# Staff Report

## Tentative Partition Plat

PA-01-20

A Tentative Partition Plat is proposed for property located at 2440 Queen Avenue SE (Attachment A). The purpose of this partition is to divide one .49-acre parcel into three parcels totaling 4,844 square feet, 7,108 square feet and 9,432 square feet, respectively (Attachment B). All three parcels are proposed to be developed with duplex units (Attachment C). Access is proposed by a flag lot configuration in conjunction with a joint access easement benefiting Parcel 1.

TENTATIVE PARTITION PLAT  
 FOR  
**JEANINE HOWELL**  
 LOCATED IN

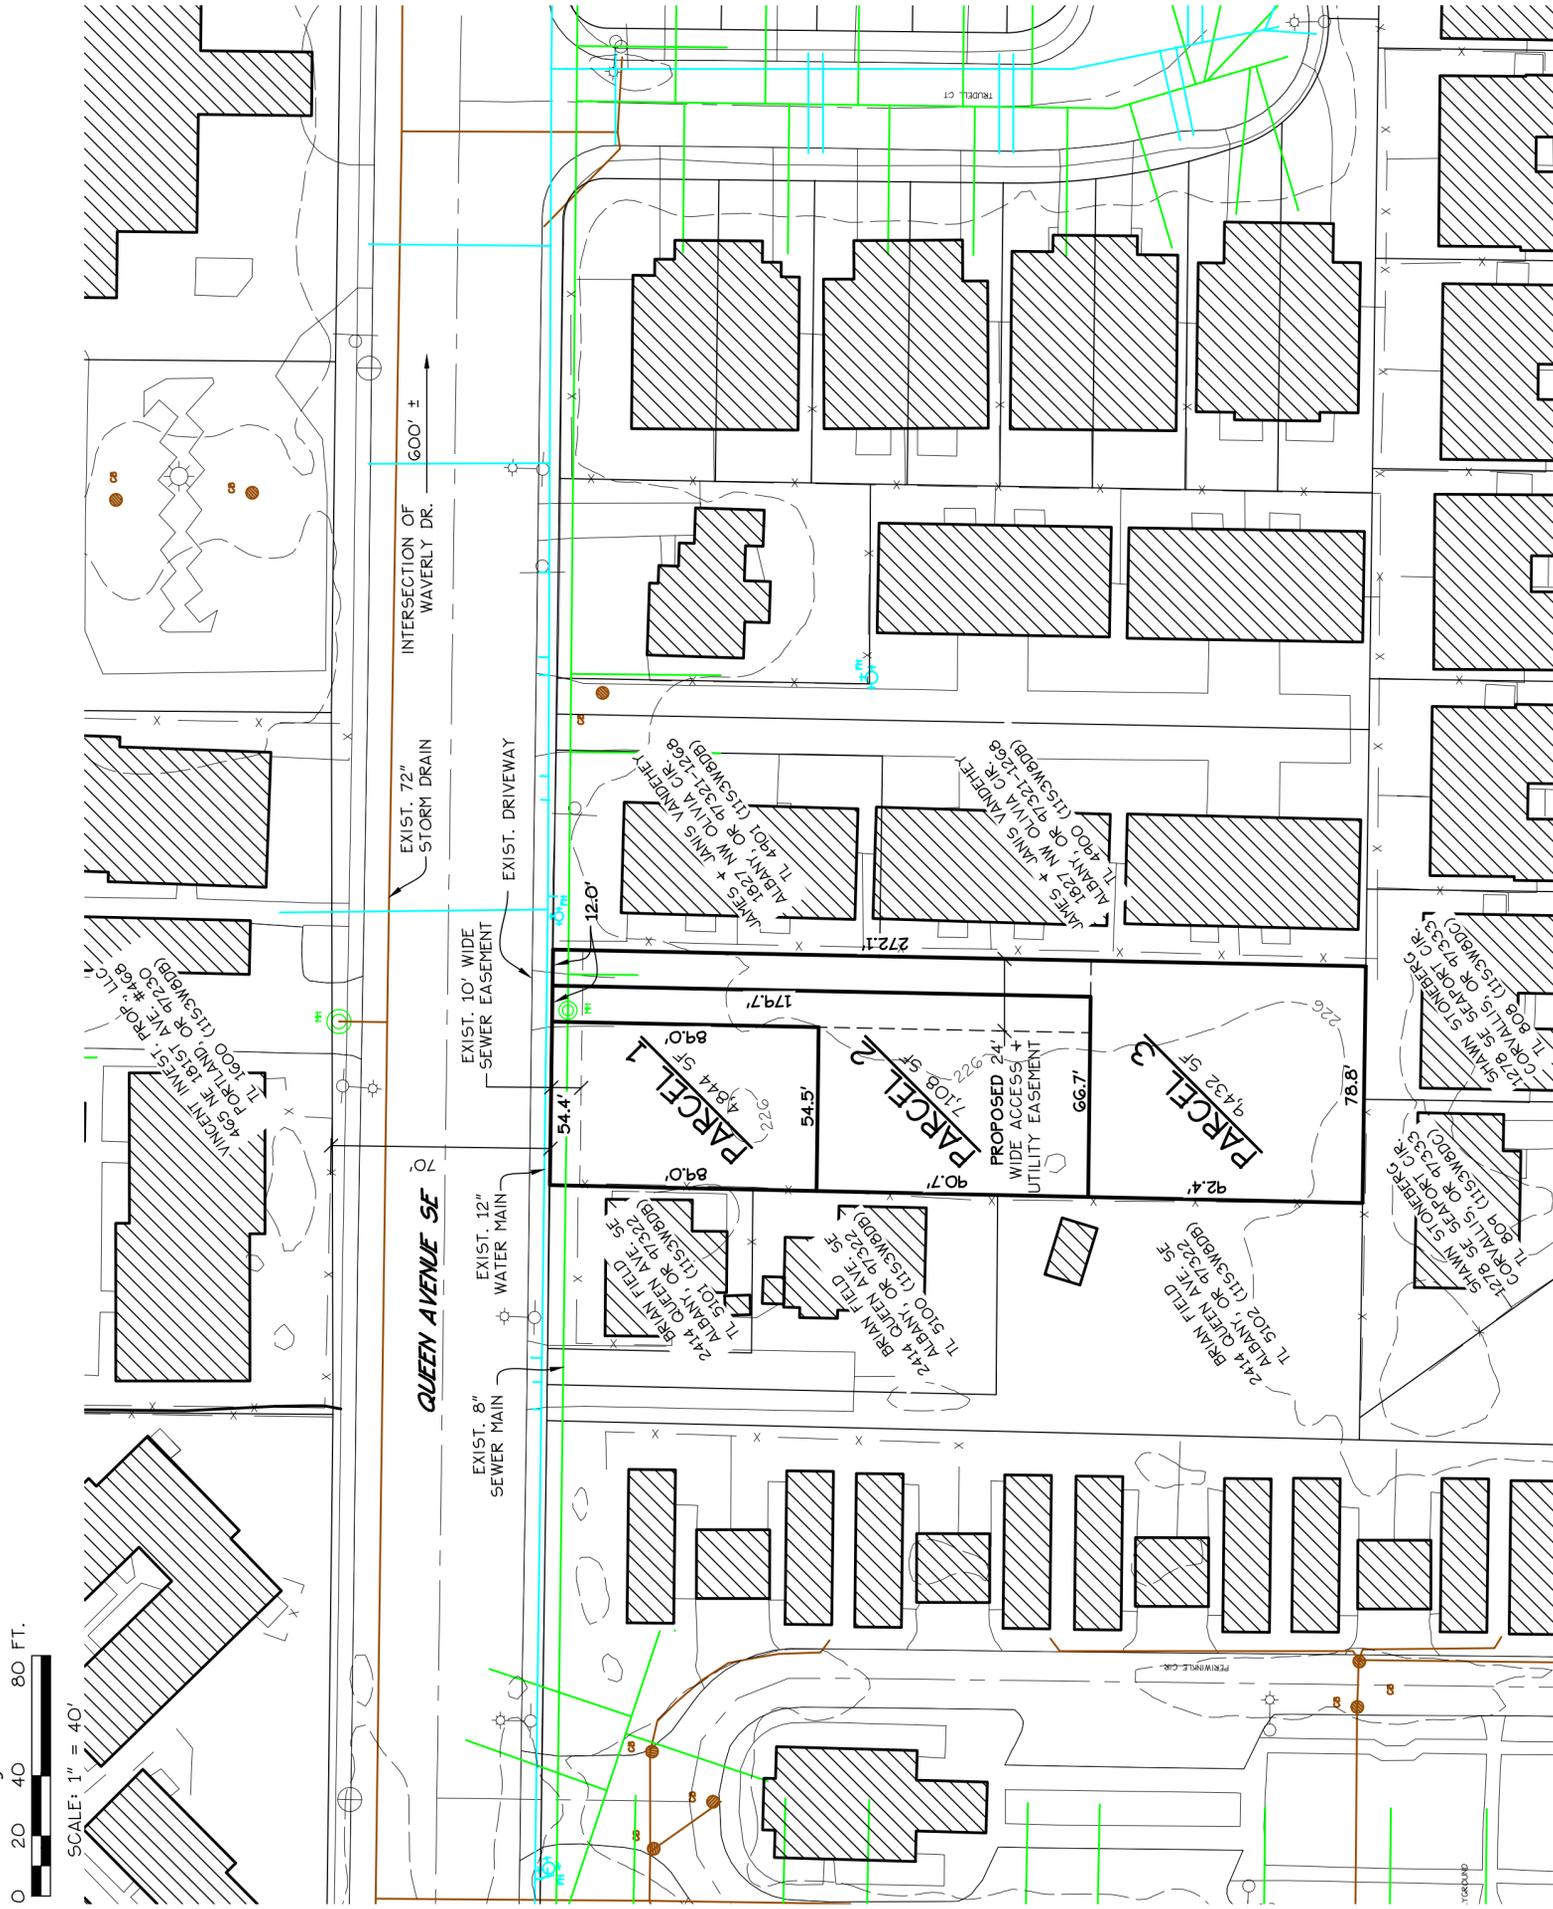
Parcels 2 and 3 are considered “flag lots.” Access to Queen Avenue will be provided to Parcel 1 via a shared access over the 12-foot-wide flag stem portions of Parcel 1 and Parcel 2, as shown on the tentative plat (Attachment B).

- 4.5 No new streets are proposed. Parcels 2 and 3 will each have a 12-foot-wide strip of land (“flag pole”) abutting Queen Avenue. A shared driveway must be constructed to service both parcels. Parcel 1 must also share this driveway so that the number of driveways to Queen Avenue is minimized. A “no access” restriction must be shown on the final plat across Queen Avenue frontage of Parcel 1. Access to Parcel 1 must be as proposed, from the shared access on the 12-foot-side “flag” of Parcels 2 and 3.

- 5.4 Each separate parcel must be served by a distinct sewer lateral connection to the public sewer main. The applicant is showing these separate connections on the submitted preliminary utility plan. The laterals serving the southern two lots will run within the shared driveway.

- 5.7 Each separate parcel must be served by a distinct water service connection to the public water main. The applicant is showing these separate connections on the submitted preliminary utility plan. The services serving the southern two lots will run within the shared driveway.

- 5.13 The applicant's preliminary plan shows the construction of a shared driveway with a shared storm drainage system in the driveway, consisting of a catch basin and piping to be connected to the public system on the north side of Queen Avenue. The southern two lots must drain to this private stormwater collection system. The shared stormwater collection system must be covered by a private utility easement.

- Condition 1** A dedication of two feet of right-of-way must be shown on the final plat along the site's frontage on Queen Avenue in order to provide sufficient right-of-way for the eventual construction of a public sidewalk to the City's standard width of seven feet

- Condition 2** A "no access" restriction must be shown on the final plat across Queen Avenue frontage of Parcel 1. Access to Parcel 1 must be as proposed, from the shared access on the 12-foot "flags" of Parcels 2 and 3.

- Condition 3** Parcels 1 – 3 share a single driveway approach to Queen Avenue. A shared access and maintenance agreement shall be recorded over the flag portions of Parcels 2 and 3 benefitting all three parcels. This may be provided on the final plat.

- Condition 4** The driveway must be paved for the entire length that is shared. The driveway must be at least 20 feet wide. The driveway must be paved before the City signs the final partition plat, or the property owner may enter into a "mutual improvement agreement" with the City that guarantees the driveway will be paved within a certain amount of time.

- Condition 5** Prior to recordation of the partition plat, the property owner/developer shall show provision of an emergency vehicle access easement over the shared accessway and any required turnaround on Parcels 2 and 3. The easement shall be for purposes of ingress and egress to provide, without limitation, fire protection, ambulances and rescue services, and other lawful government or private emergency services to the premises, owners, occupants, and invitees.

- Condition 7** Before the City will approve the final partition plat, the applicant must construct the private storm drainage system within the shared driveway and make connection to the public storm drainage facility in Queen Avenue. All required permits must be obtained from the Public Works Department before beginning work in the public right-of-way. (The applicant may provide financial assurances for this work in order to obtain City approval of the plat.)
- Condition 8** Before the City will sign the final partition plat, the applicant must pay a water connection charge for the existing public water facilities along the property's Queen Avenue frontage.
